January 10, 2020 UPDATE (6<sup>th</sup> Supplemental Submittal)

**RE: KMART REDEVELOPMENT – DRB SUBMITTAL FOR SITE PLAN**

**DRB PROJECT NUMBER: PR –2019–002677**  
**APPLICATION NUMBER: SI-2019-00252**

PROJECT MANAGER: STEPHEN DUNBAR, AIA  
 SHEET TITLE: SITE PLAN FOR BUILDING PERMIT

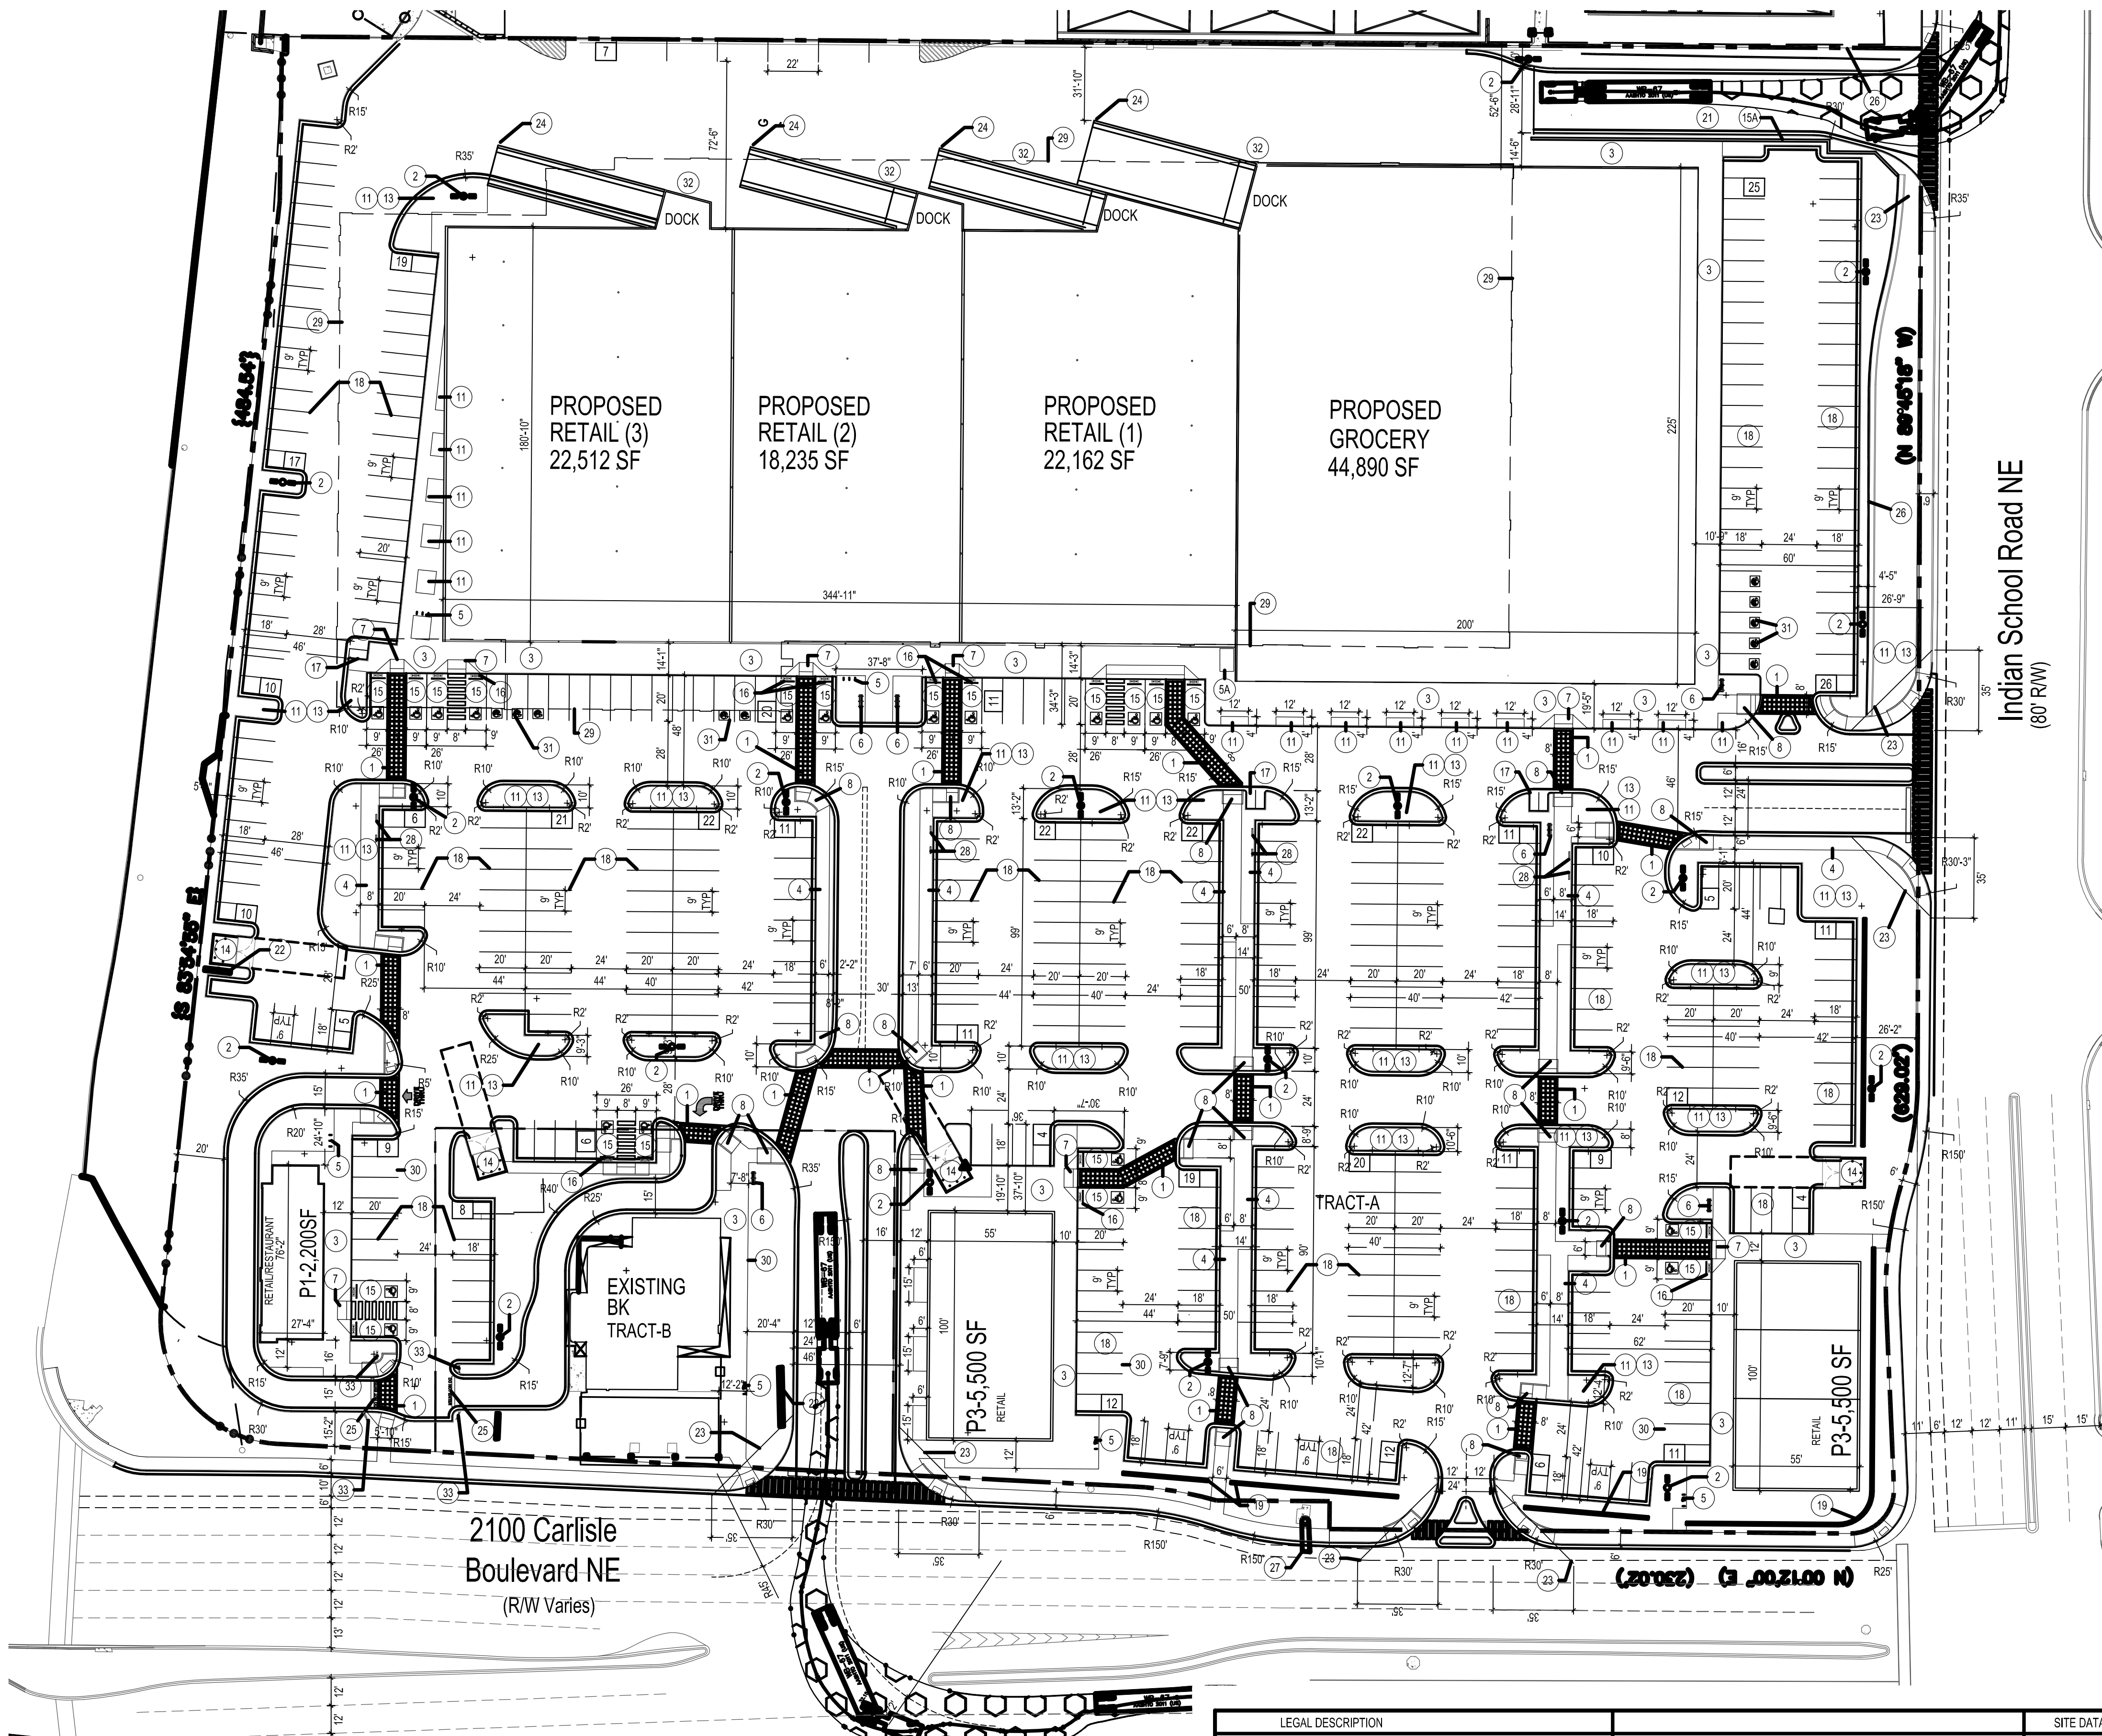
5. Dimensioning (existing and new) for all lanes on Carlisle Boulevard and Indian School Road including the 6-foot bike lane has been provided, but it is unclear whether curb needs to be relocated or road striping needs to be done for Indian School Road. Once this is defined, it needs to be reflected for improvements to Indian School Road on the infrastructure list.
  - a. **See BP-1 Site Plan and Infrastructure List**

- b. Is the curb and gutter along the east side overtop the existing 10" waterline new or existing? It is not labeled on the Site Plan. If new, curb and gutter will not be allowed overtop public waterline, so additional relocation will be required and reflected in the infrastructure list.

- i. **See relocated curb and gutter on the east side on BP-1- Site Plan**

16 CURBED RAMP DETAIL  
N.T.S.

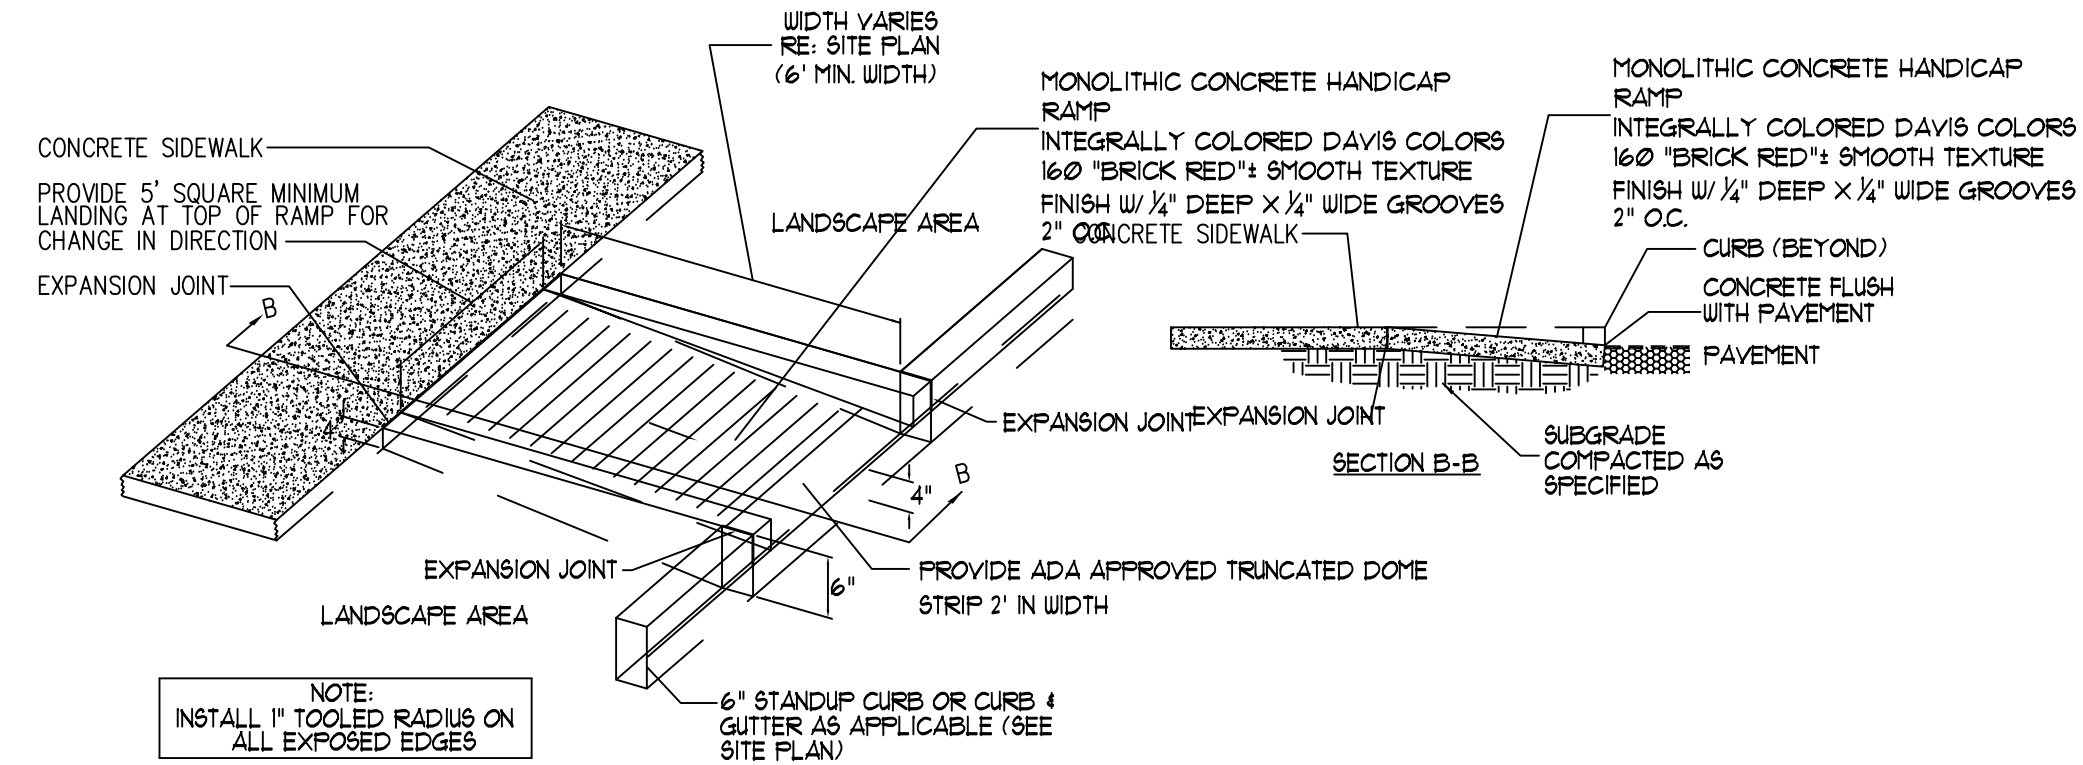
6. On Sheet A1.1, where is cross-section A-A for the curb ramp?
  - a. **See sheet A1.1 - Site Details, note 16 (See bottom right corner of note 16 "Section B-B")**

11 H.C SIGNAGE  
N.T.S.

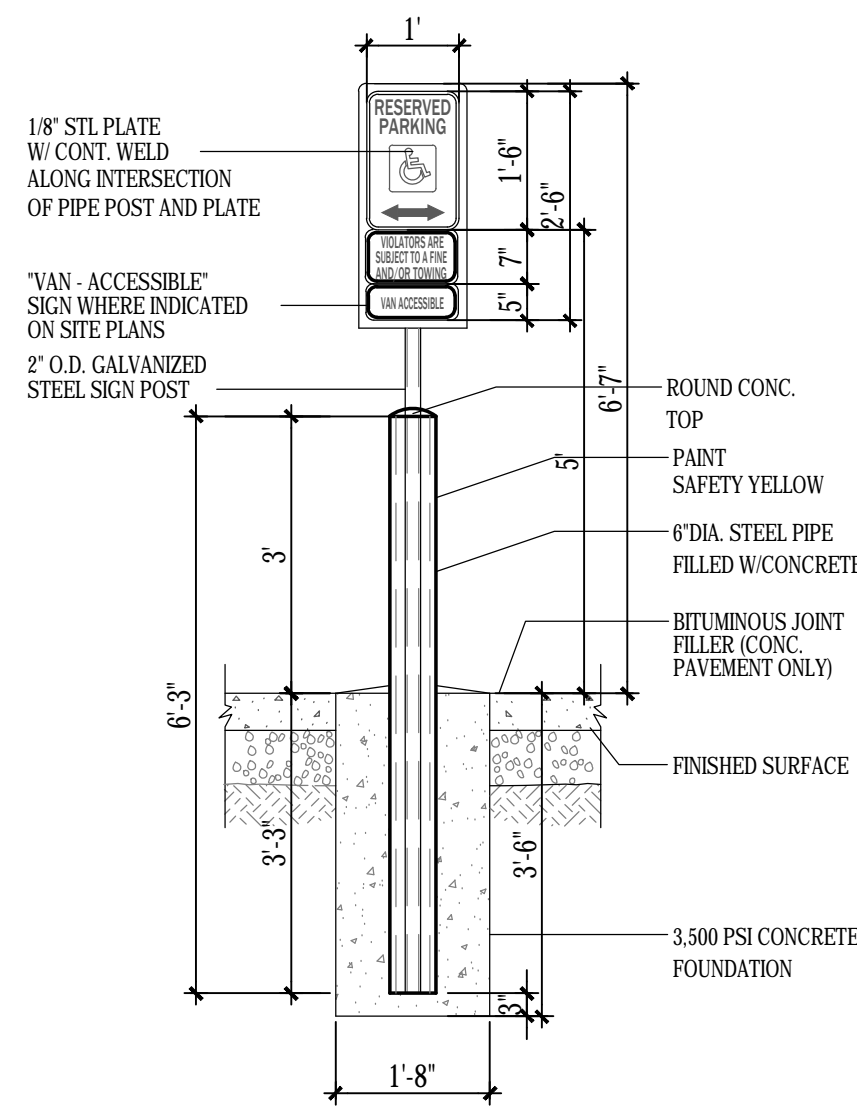
8. The ADA accessible parking sign must have the required language per 66-7-352.4C NMSA 1978 "Violators Are Subject to a Fine and/or Towing." If that language is present it is not visible in the detail.
  - a. **See Sheet A1.2 Site detail, note 11.**

2 H.C PARKING PLAN DETAIL (VAN ACCESSIBLE)  
N.T.S.

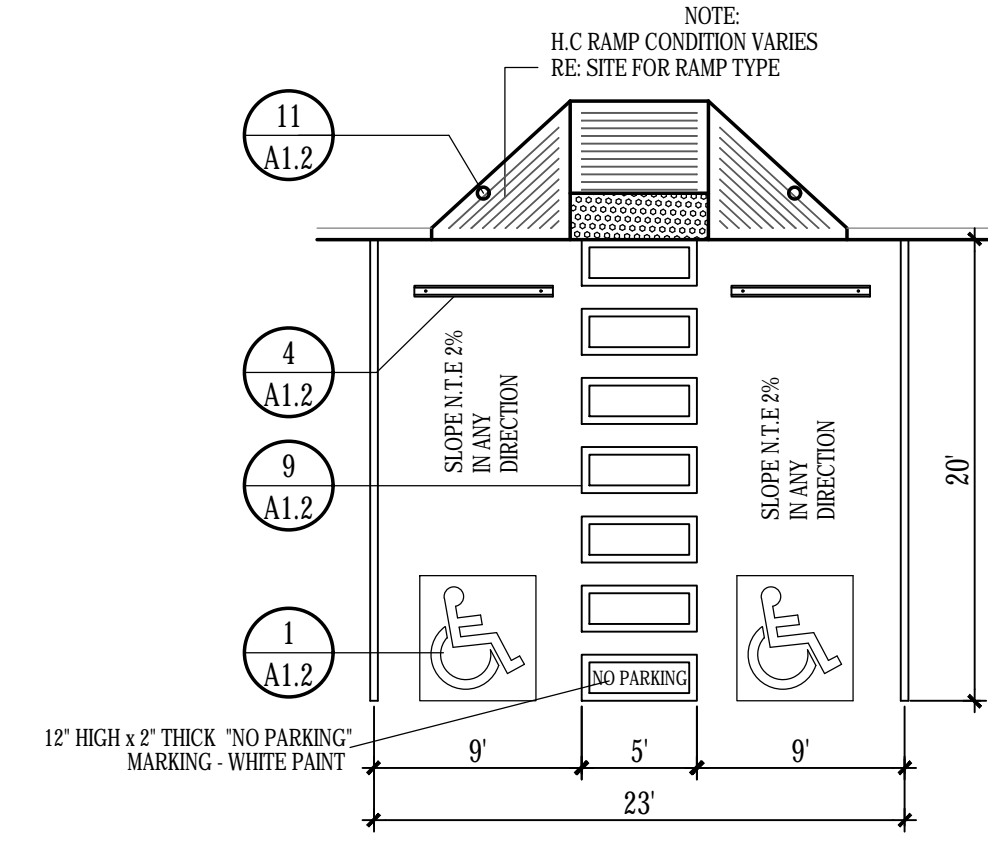
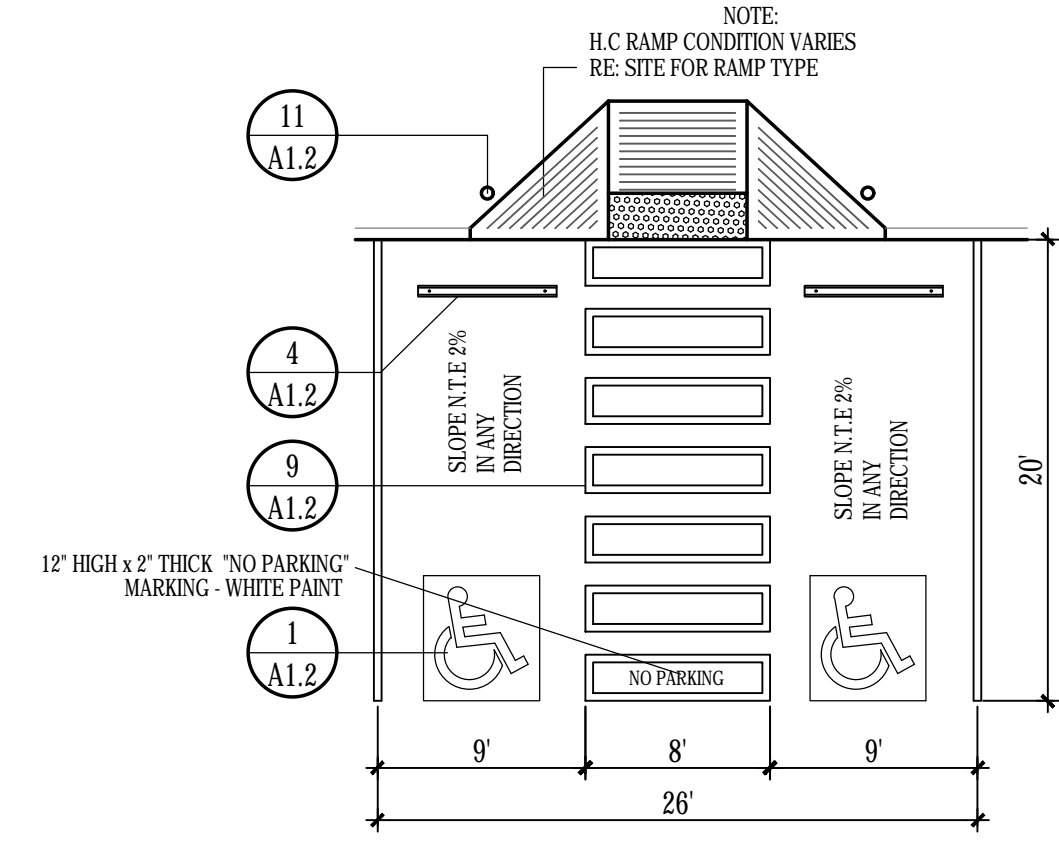
7. The ADA access aisle shall have the words "NO PARKING" in capital letters, each of which shall be at least one foot high and at least two inches wide, placed at the rear of the parking space so as to be close to where an adjacent vehicle's rear tire would be placed. (66-1-4.1.B NMSA 1978)
  - a. **See Sheet A1.2 - Site detail, notes 2 and 3.**
